STATE OF MAINE  
DEPARTMENT OF TRANSPORTATION  
16 STATE HOUSE STATION  
AUGUSTA, MAINE 04333-0016

December 6, 2018  
Subject: Hodgdon Mills Bridge  
Bridge Replacement  
State WIN: 022638.00  
Location: **Hodgdon**  
**Amendment No. 1**

Temporary Traffic Figure

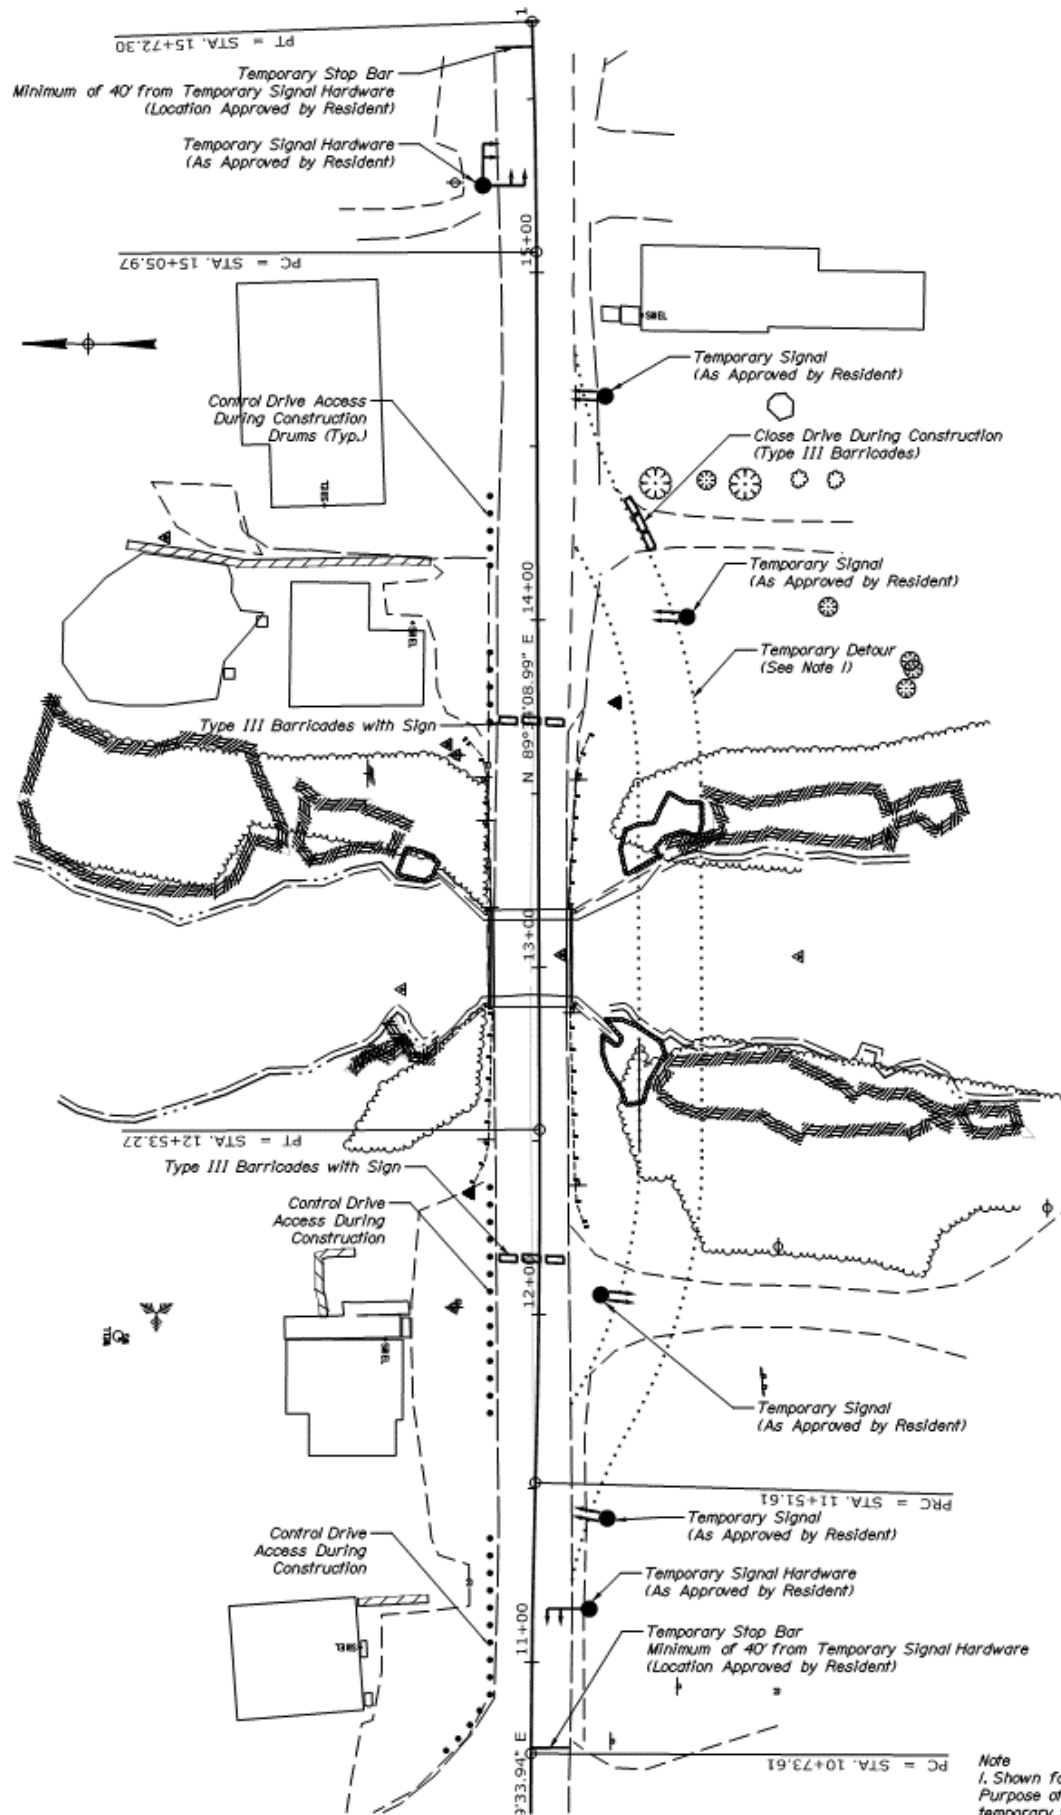
**REMOVE** pages 71 – 72, SPECIAL PROVISION - SECTION 643 - TRAFFIC SIGNALS - (Temporary Traffic Signal), 2 pages, dated October 29, 2018, and **REPLACE** with the attached, revised SPECIAL PROVISION - SECTION 643 - TRAFFIC SIGNALS -(Temporary Traffic Signal), 2 pages, dated November 29, 2018.

The Contractor shall install and maintain a temporary traffic signal system for the project duration. See Temporary Traffic Figure.

Signal heads shall also be provided for the drives within the work zone and mounted on a temporary structure supplied by the Contractor and approved by the Resident. Two heads shall face each drive as shown in the Temporary Traffic Figure. All signal heads shall have 8" minimum R-Y-G circular indications with 5" backplates. A "No Right Turn On Red" sign shall be installed at each drive.
